SUBJECT: Forwards draft proposed FSAR changes, including revs to steam
 supply logic & recirculation flow path for auxiliary
 feedwater sys to correct nuclear cooling water sys
 flowrates.Changes will be incorporated in FSAR Amend 14. *56.6 rpt*

Enclosed for your information are draft proposed FSAR changes. These changes 1) identify the presence of essential HVAC to cool the essential spray pond pumphouse, 2) revise the steam supply logic and recirculation flow path for the auxiliary feedwater system (Reference 1 and 2), 3) correct nuclear cooling water system flowrates, 4) clarifies the closure time of the main steam stop valves, 5) update the listing of safe shutdown equipment in accordance with the spurious actuation analysis submitted in Reference 3, 6) delete the letdown line low flow alarm, and make editorial corrections and clarifications. These changes are considered acceptable as 1) the essential HVAC meets design criteria as described in section 3.2, 2) the auxiliary feedwater system changes are consistent with CESSAR safety analyses, 3) the nuclear cooling water flowrates meet design requirements, 4) the revised closure time of the stop valves is consistent with the man

FIG 9B-44

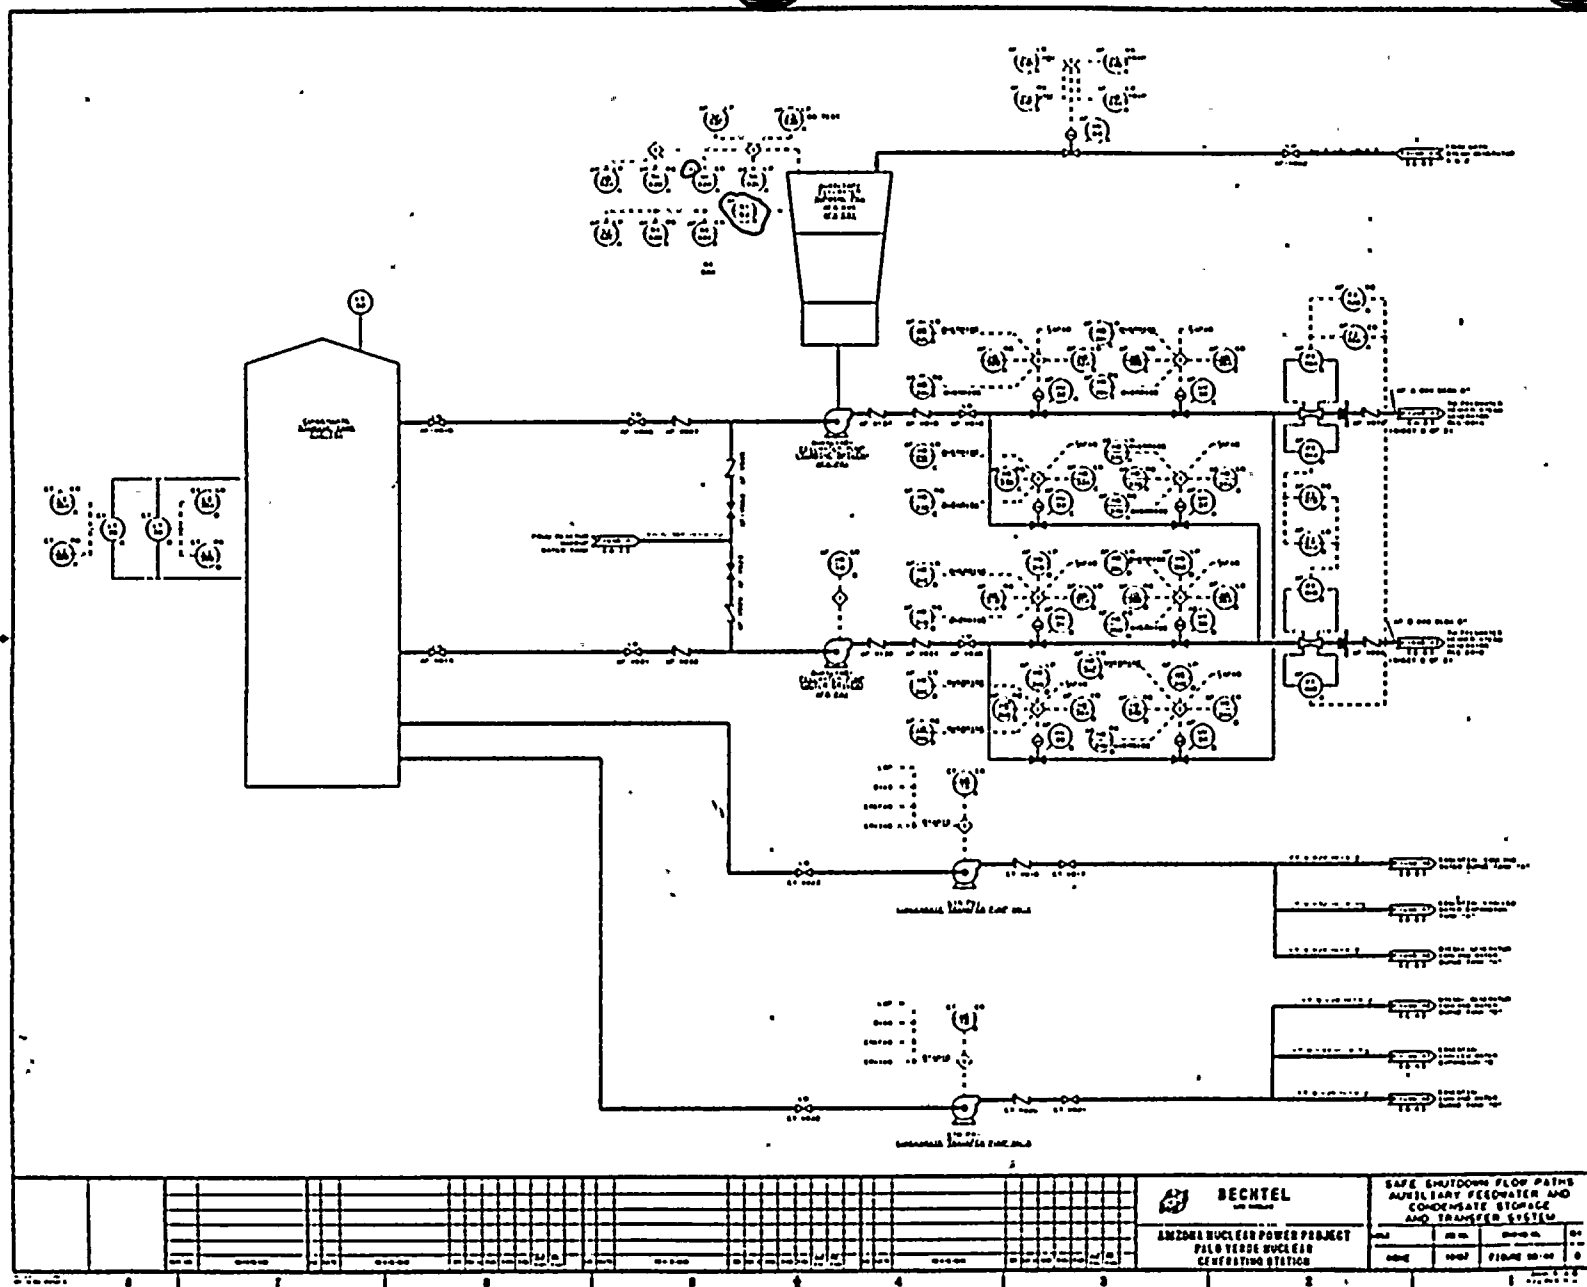
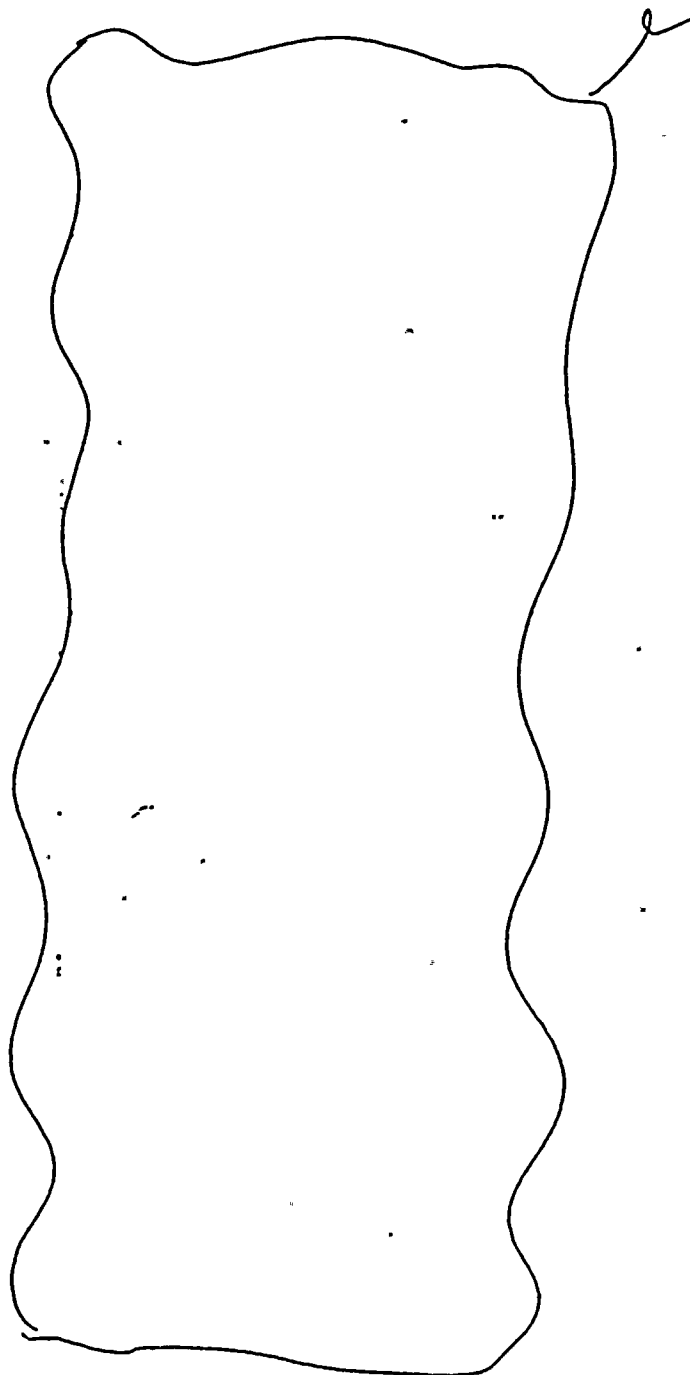
REPLACE
w/ ATTACHED
FIG 9B-44

CHANGE

FIG 9B-47

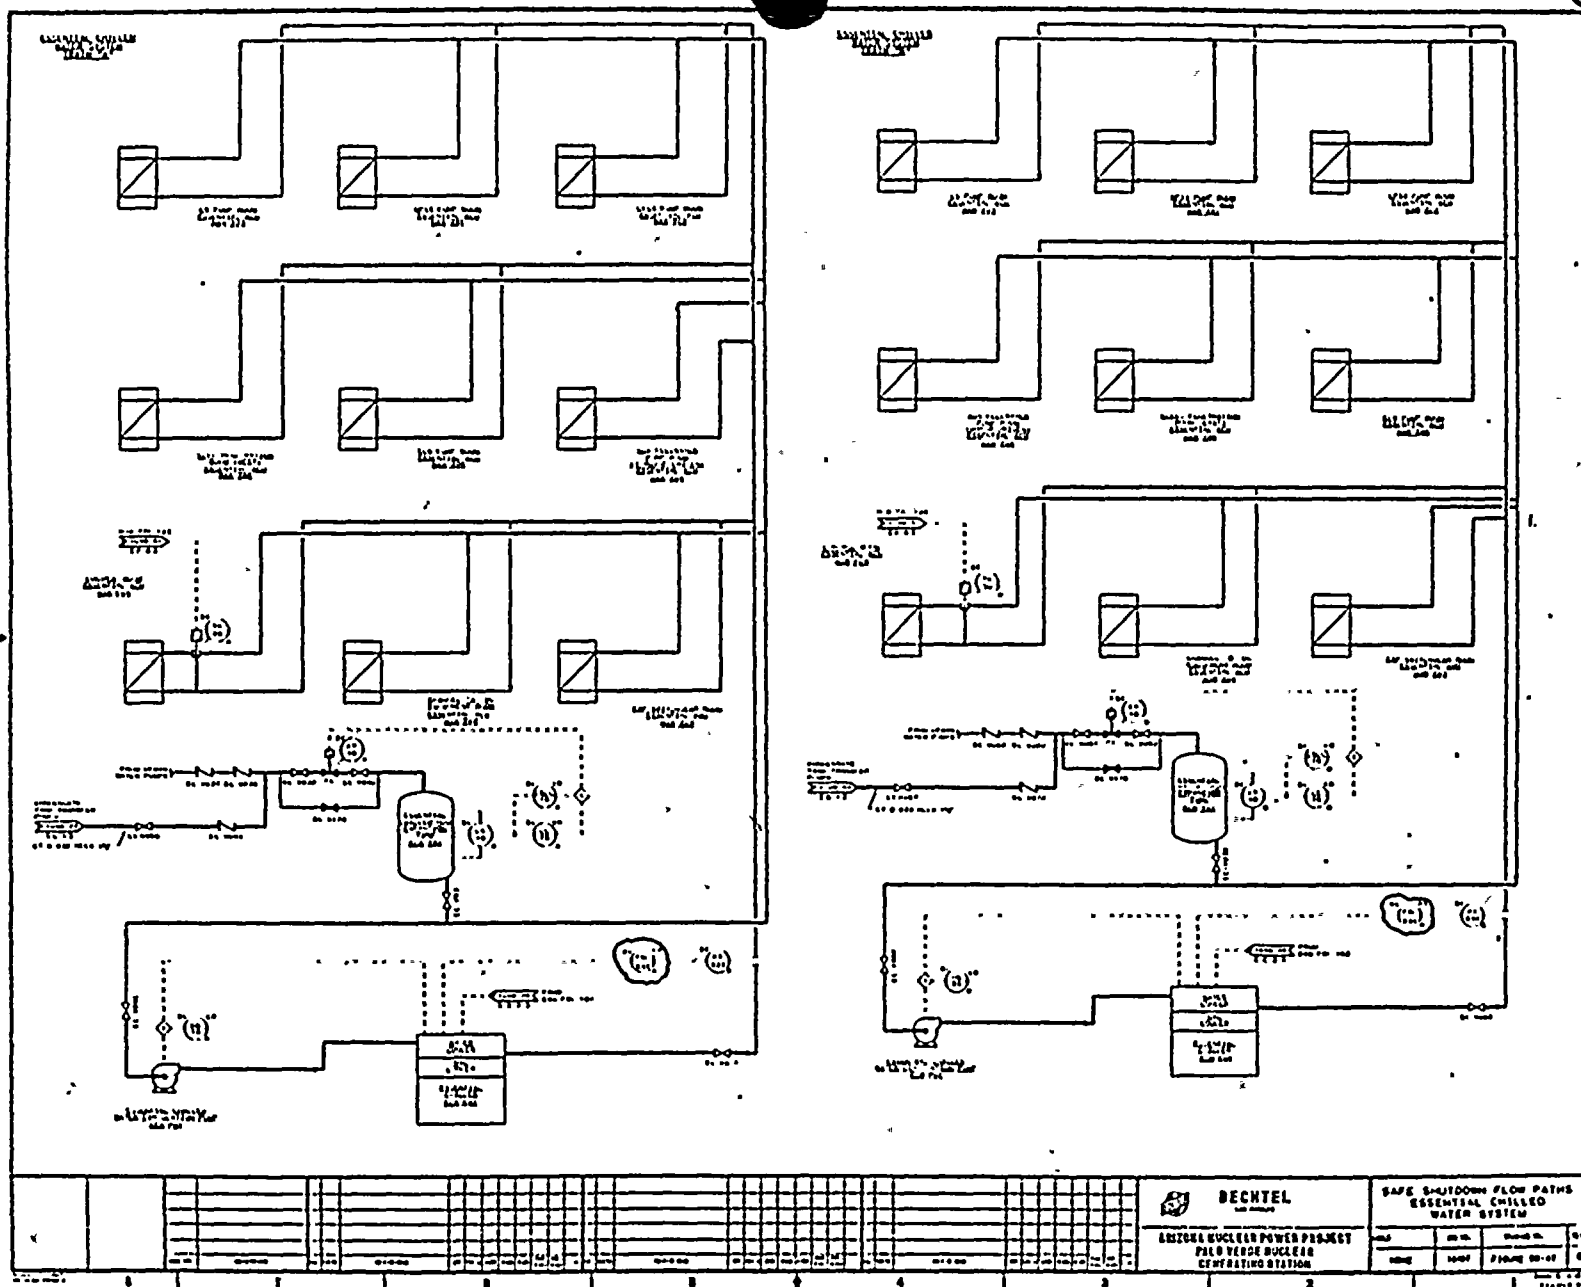
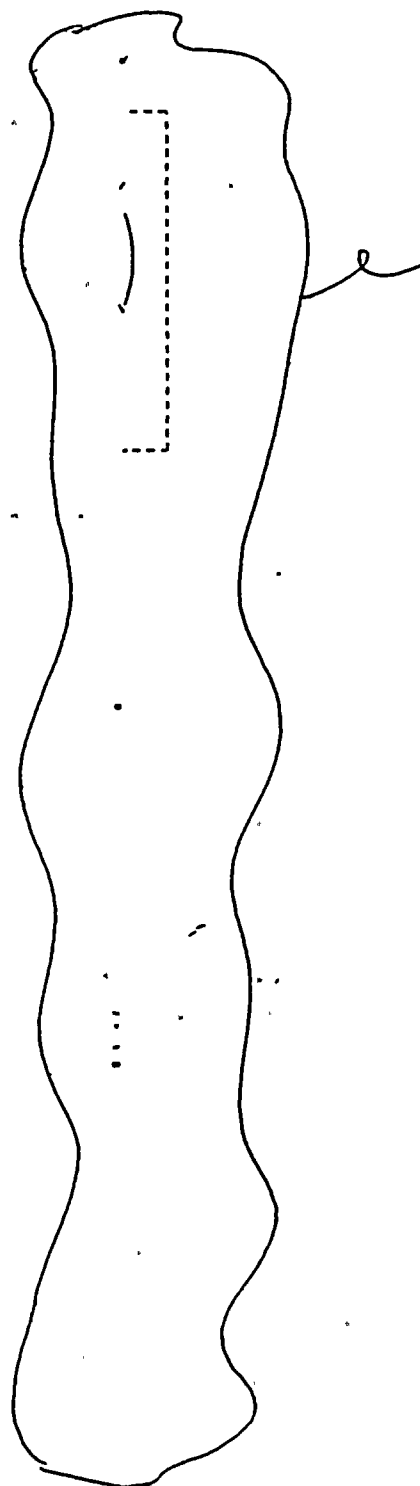
REPLACE
W/ ATTACHED
FIG 9B-47

CHANGE

FIG 9B-48

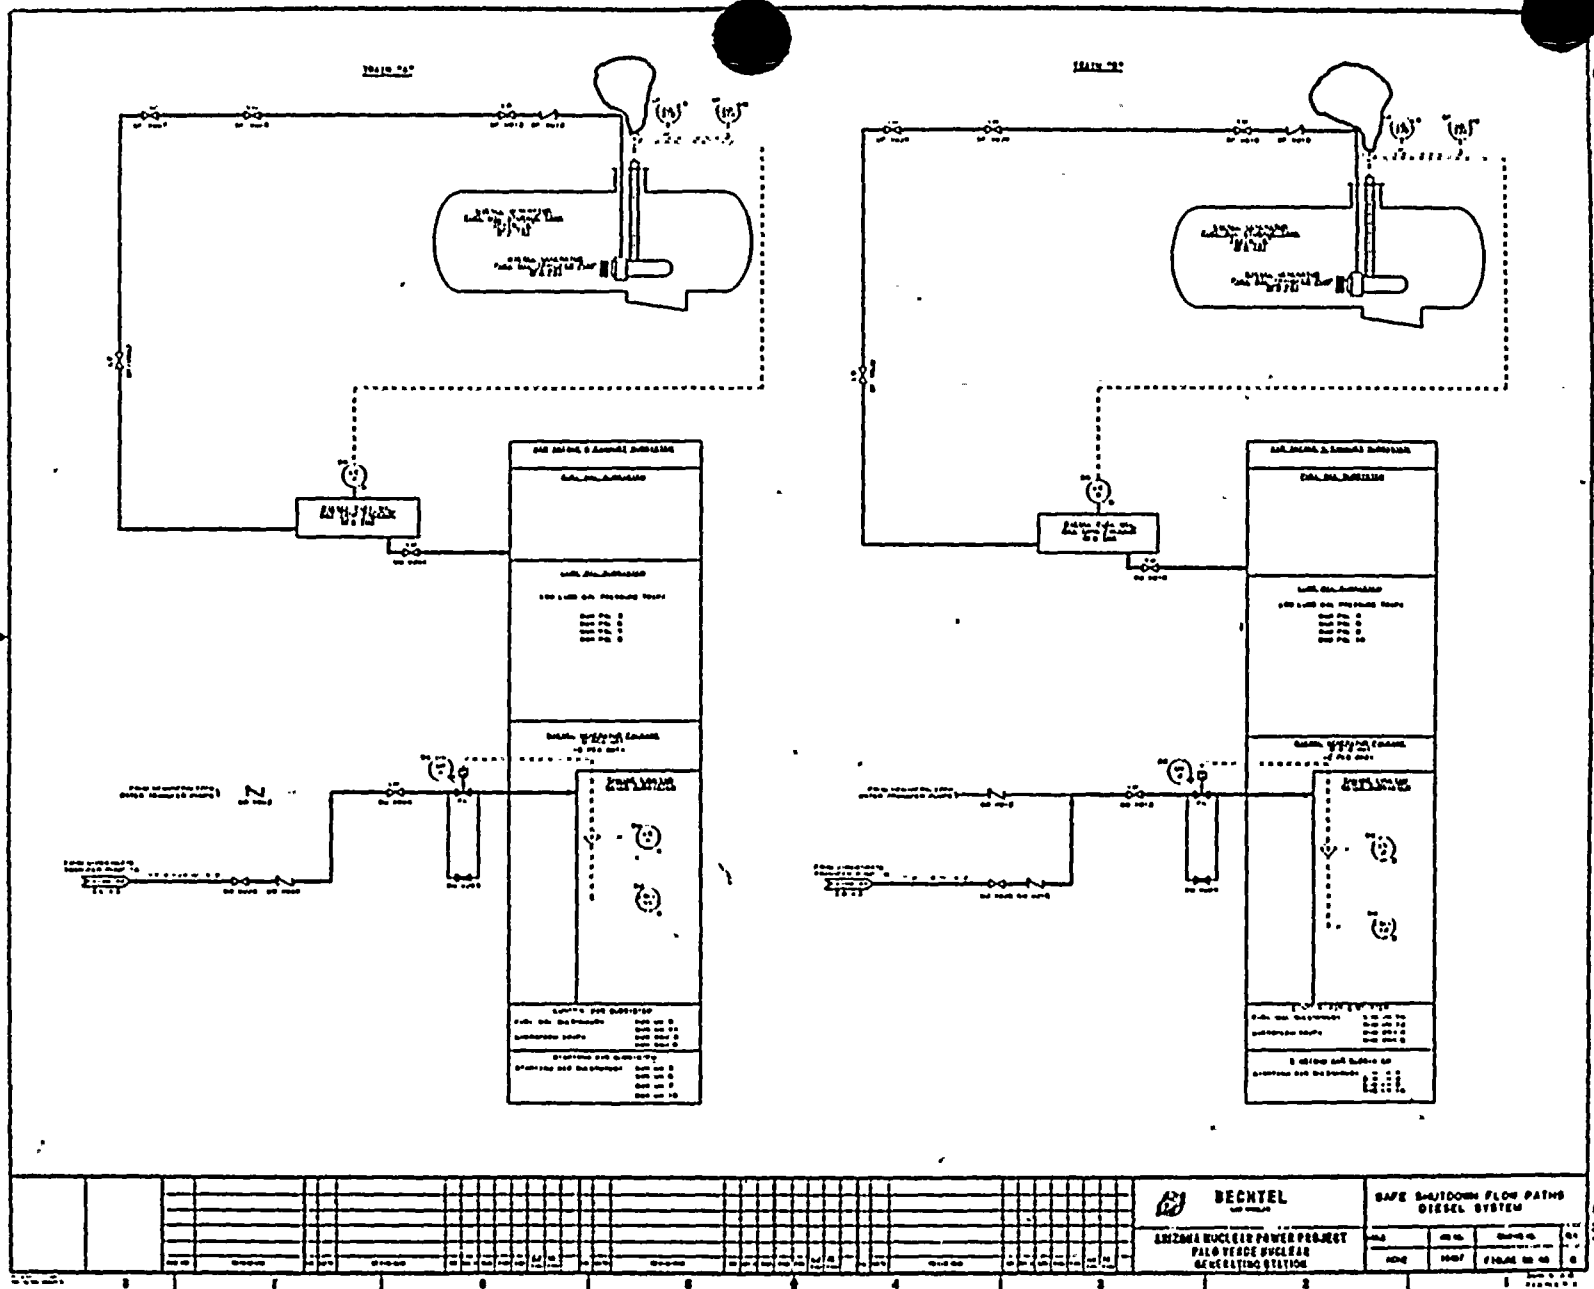
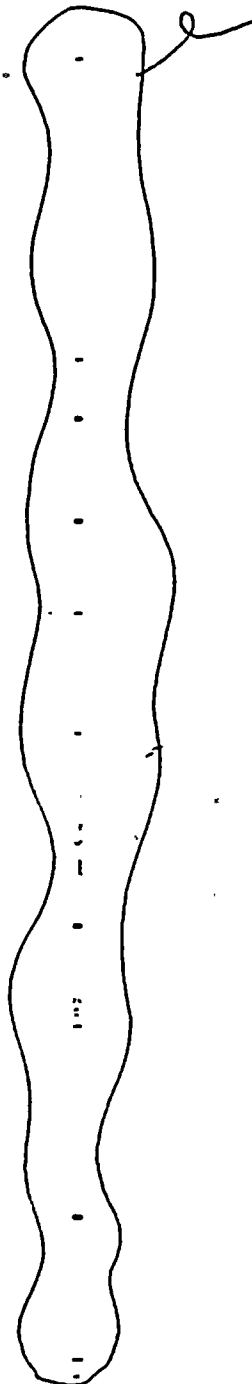
REPLACE
w/ ATTACHED
FIG 9B-48

CHANGE

PVNG7
FSAP
SCHEMATIC DIAGRAM
PUBLIC ADDRESS EQUIPMENT
FIG. 9-5-3

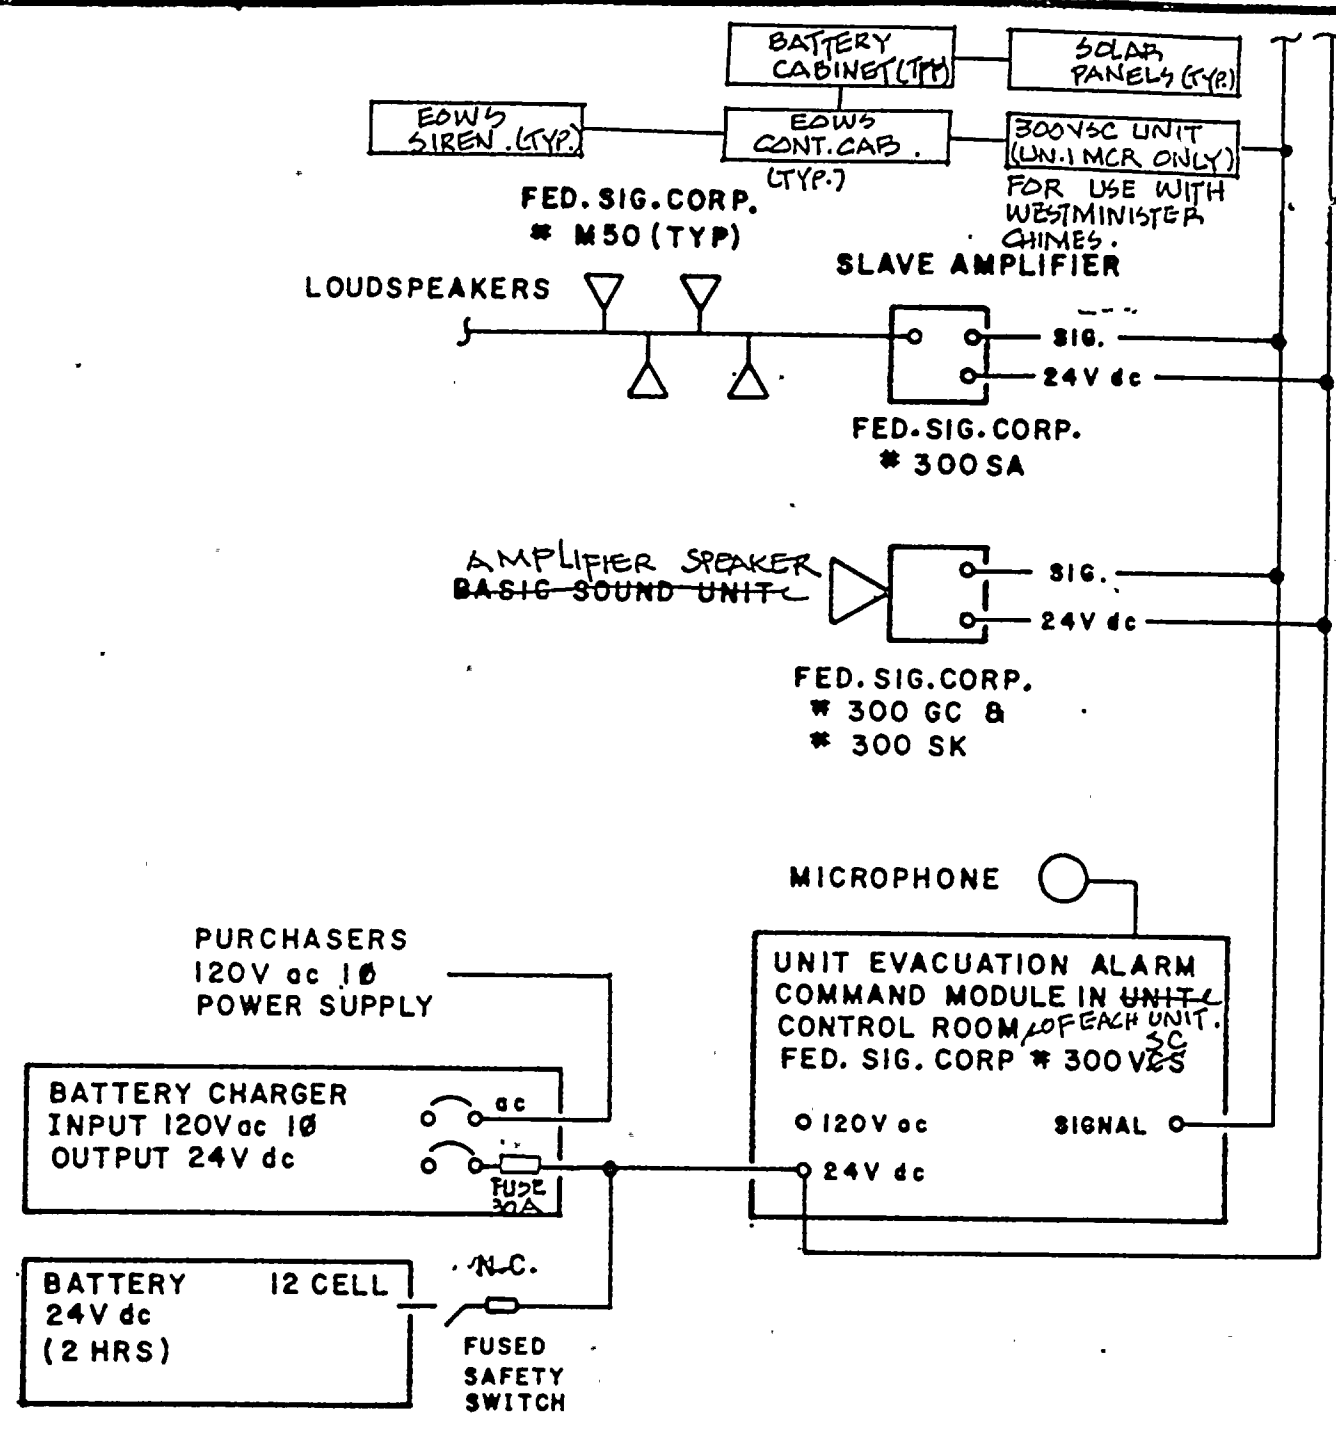
Replace existing layout with this new one.
